1966 Corvette: Service Bulletin: Automatic Choke Malfunction

Subject: Automatic Choke Malfunction

Source: Chevrolet Technical Service Bulletin

Bulletin No: TSB #66-6, DR #66-6

FIG. I - CHOKE THERMOSTAT ASSEMBLY - 283 V-8

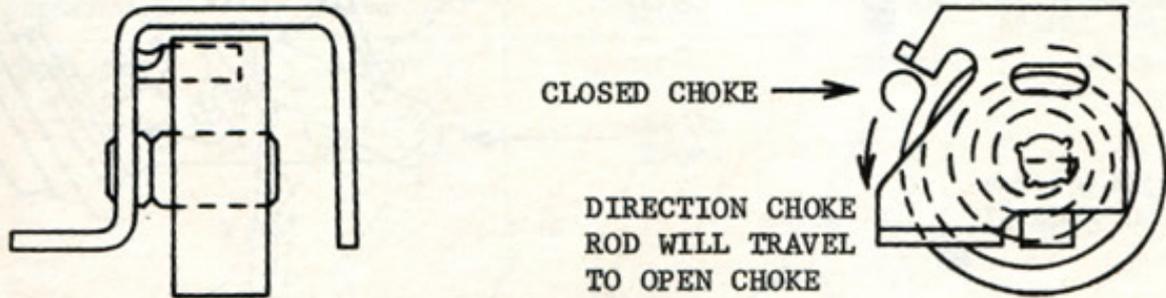
NOTE: Choke thermostat assemblies, although similar in appearance, are not interchangeable. Check bracket design as shown in Figures I, II and III and the coil spring identification number shown on chart (Number stamped in coil, not number in ink). Choke coil springs are indexed to bracket and must not be interchanged or repositioned.

FIG. IV - ROCHESTER 4MV (QUADRA JET) VACUUM BREAK ASSEMBLY

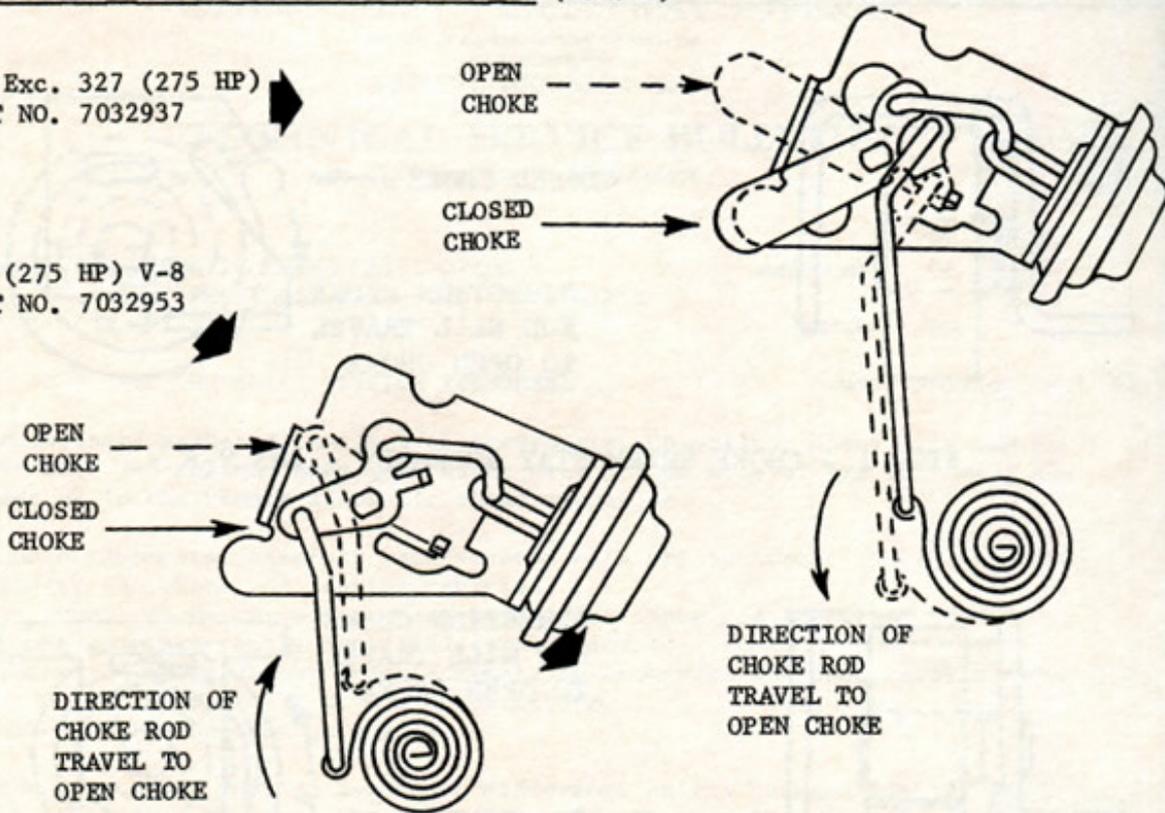
V-8 Exc. 327 (275 HP)
PART NO. 7032937

327 (275 HP) V-8
PART NO. 7032953

1. Remove carburetor air horn as outlined on Page 6M-25 of the 1966 Chassis Overhaul Manual.
2. Remove retaining screw from choke vacuum break assembly, then remove assembly.
3. Remove choke lever from float bowl well.
4. Install choke vacuum break assembly as outlined on Page 6M-27, Steps 5, 6, and 7 of the 1966 Chassis Overhaul Manual.
5. Install carburetor air horn as outlined on Page 6M-29 of the 1966 Chassis Overhaul Manual.

FIG. V - HOLLEY CHOKE LEVER AND VACUUM BREAK ASSEMBLY

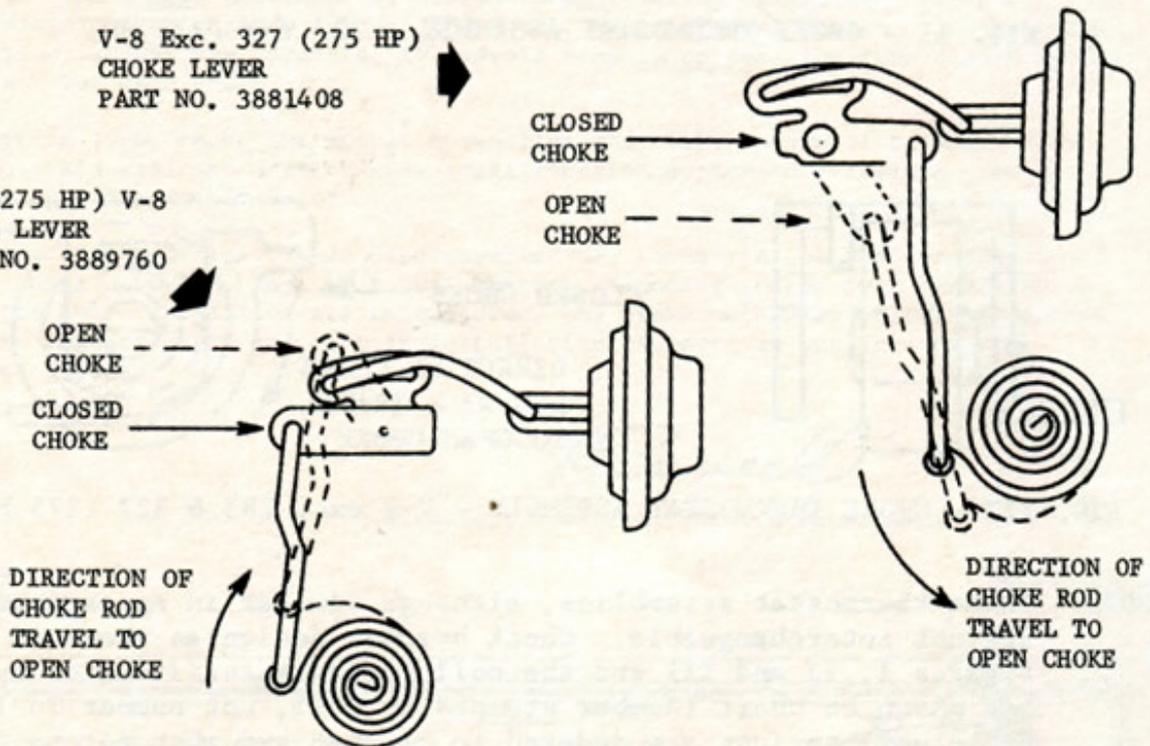
V-8 Exc. 327 (275 HP)
CHOKE LEVER
PART NO. 3881408

327 (275 HP) V-8
CHOKE LEVER
PART NO. 3889760

Disconnect choke vacuum break link, then remove choke lever retainer and choke lever. Reverse procedure to replace.
